Response to request for review for Project 0264: Waste heat based 7 MW Captive Power Project

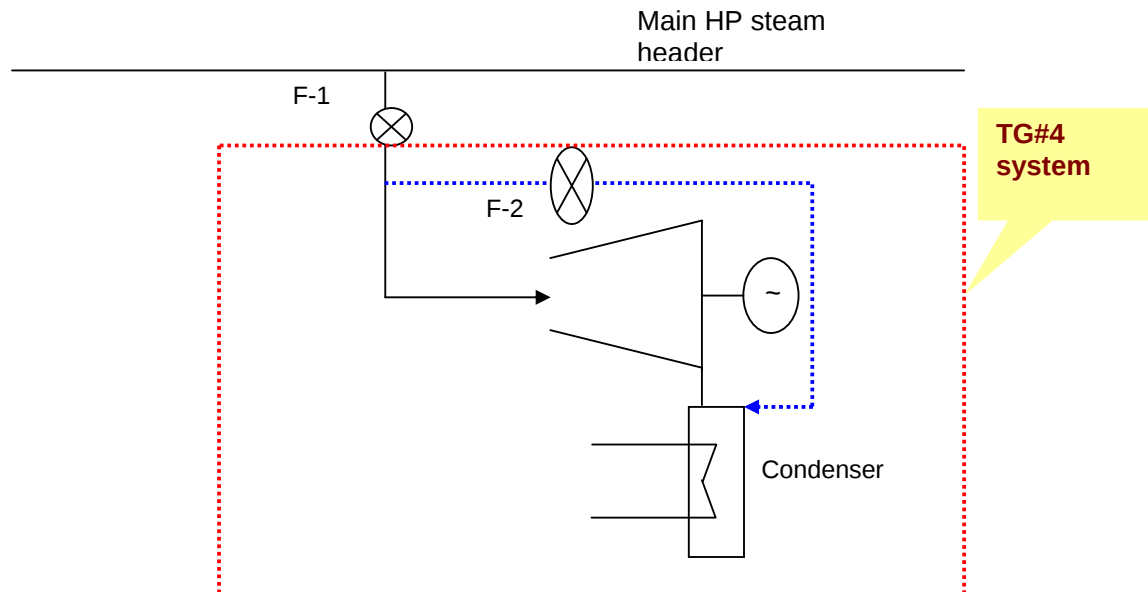
What is the origin/source of the parameter 15: TG#3 Auxiliary Steam Flow? PDD of the project 0772 "Waste Heat based 10 MW captive power project "GPIL- WHRB 2" does not provide any information on this.

The same with the parameter 16: TG#4 Auxiliary Steam Flow.

How TG#3 Steam consumption is obtained, through online measurement or calculated as a sum of TG#3 Inlet Steam Flow and TG#3 Auxiliary Steam Flow.

The same with TG#4 Steam consumption.

'Auxiliary steam flow' in TG represents the steam consumption in the steam-jet ejector used for creating vacuum in the condenser located at the TG outlet. However, 'TG#3 Auxiliary Steam Flow' has no importance for the calculation of emission reductions for the project activity and hence, the same parameter (parameter 15 mentioned in the Monitoring Report) is deleted from the revised Monitoring Report.

Clarification request no. 1 (CR 1) was raised during the verification process to clarify the parameter 'TG#3 Auxiliary Steam Flow' and explain its impact on emission reduction

calculations. It was clarified that auxiliary steam is the steam required in ejector system to create vacuum in condenser of TG #3. It was also clarified that steam flow to TG #3 is measured before the auxiliary steam is extracted from the turbine. Based on these arguments the audit team concluded that parameter 'TG#3 Auxiliary Steam Flow' does not have any impact on the emission reduction calculations for the 0264 project activity. However, following the request for review for the project 0264, further clarifications were requested from the project proponent and it was clarified that auxiliary steam for TG #3 is tapped before steam flow to TG #3 is measured. This will not have any impact on the emission reduction calculations for the 0264 project activity.

In case of TG#4 the 'Auxiliary Steam Flow' is measured due to the following positioning of the flow meter:

In case of TG#4 there is a bifurcation of the steam-line which is going to TG#4 system. From this bifurcation an Auxiliary Steam Line is going to the condenser; auxiliary steam is utilized in the ejector used to maintain vacuum in the condenser. One flow transmitter viz. F-1 (Tag No.: FT-001, Make: Tata Honeywell) is installed before steam-line bifurcation takes place and the other flow transmitter F-2 (Tag No.: FT-406, Make: Tata Honeywell) is installed in the Auxiliary Steam Line to monitor the auxiliary steam flow to the condenser.

The auxiliary steam-flow data recorded by F-2 is deducted from the steam-flow data recorded by F-1 to arrive at the inlet steam flow to TG#4. Both the steam-flow data recorded by F-1 and F-2 are monitored on-line through DCS.

Contrary to TG#1, TG#2, TG#3 in-let steam consumption, TG#4 inlet steam consumption is a calculated parameter which is obtained by the difference between steam-flow from main HP steam-header to TG#4 system and the TG#4 auxiliary steam flow. Please refer to the diagram mentioned in the reply provided against Item No 2 for further clarification.
